Subject: Agenda for 58th Protection Sub-Committee Meeting.

Agenda of 58th Protection Sub-Committee Meeting (26th March, 2025)

**Agenda for
58th Meeting of Protection Sub-Committee (PSC) of
Northern Regional Power Committee**

Fig. 2 Schematic diagram for implementation of proposed SPS Logics

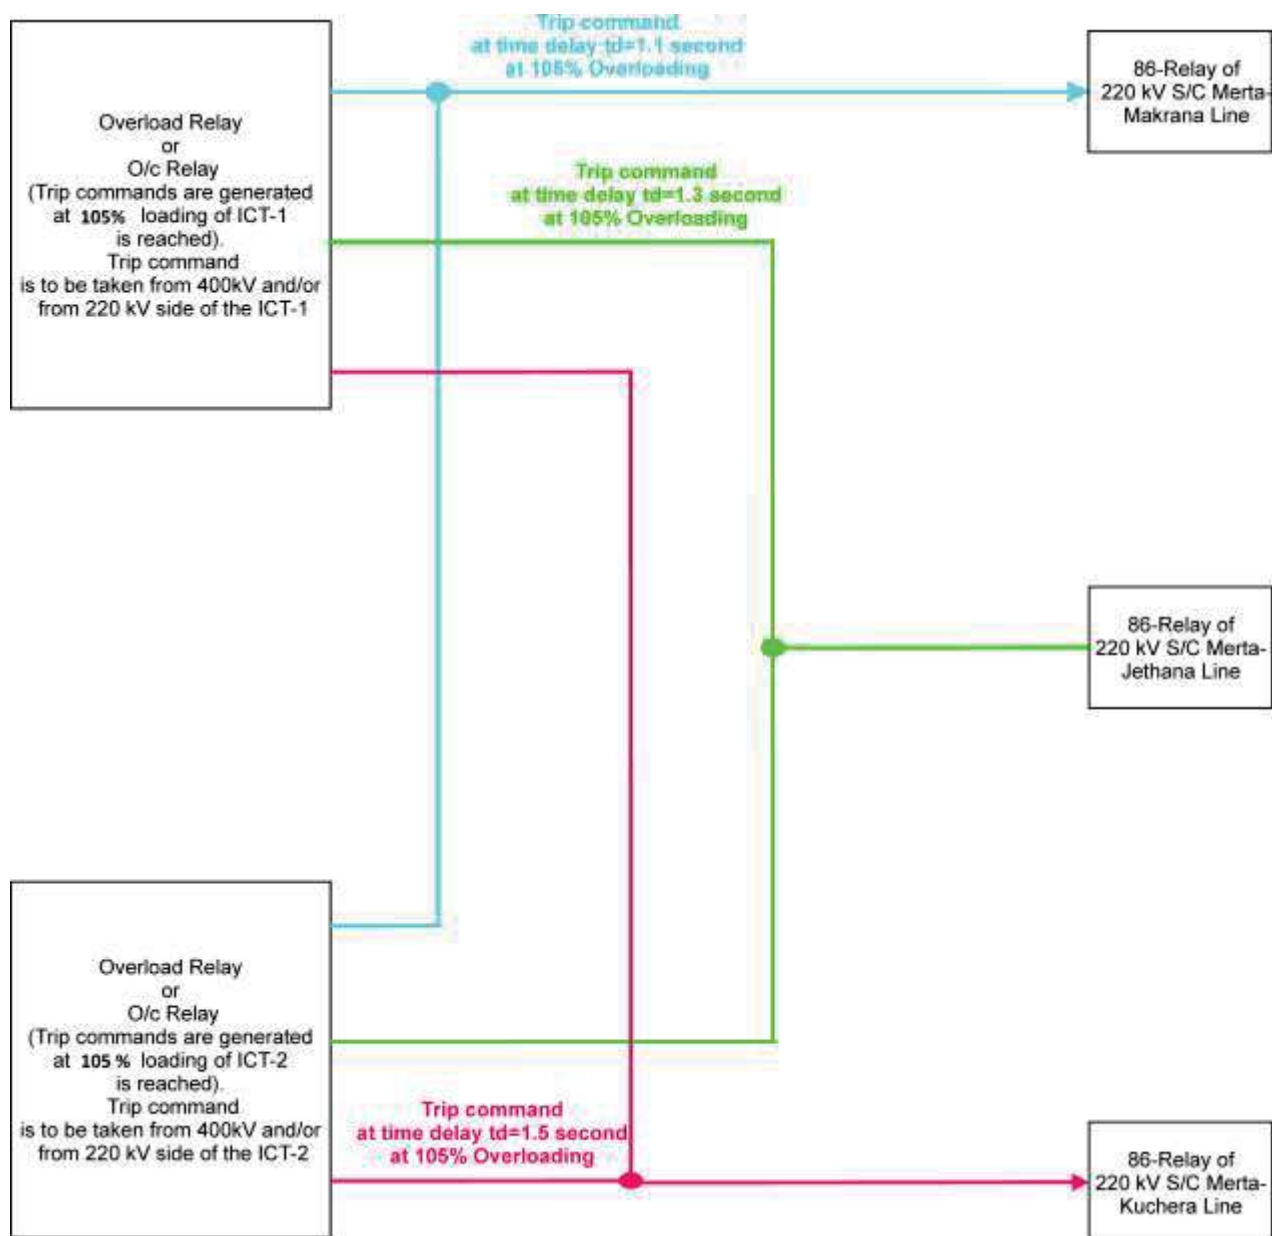
- Ajmer: Proposed SPS seems to be in order in general as per NRLDC.
- Merta: 220/132kV Merta ICTs not shown in diagram.
- Chittorgarh: Other 220kV line may also need to be added as sought relief may not be provided.

Rajasthan representative agreed to look into the comments from NRLDC side. Rajasthan was given in-principle approval for implementation of SPS at 400/220kV Ajmer, Merta and Chittorgarh, expedite implementation of SPS, and share revised ATC/TTC assessment of Rajasthan state control area.
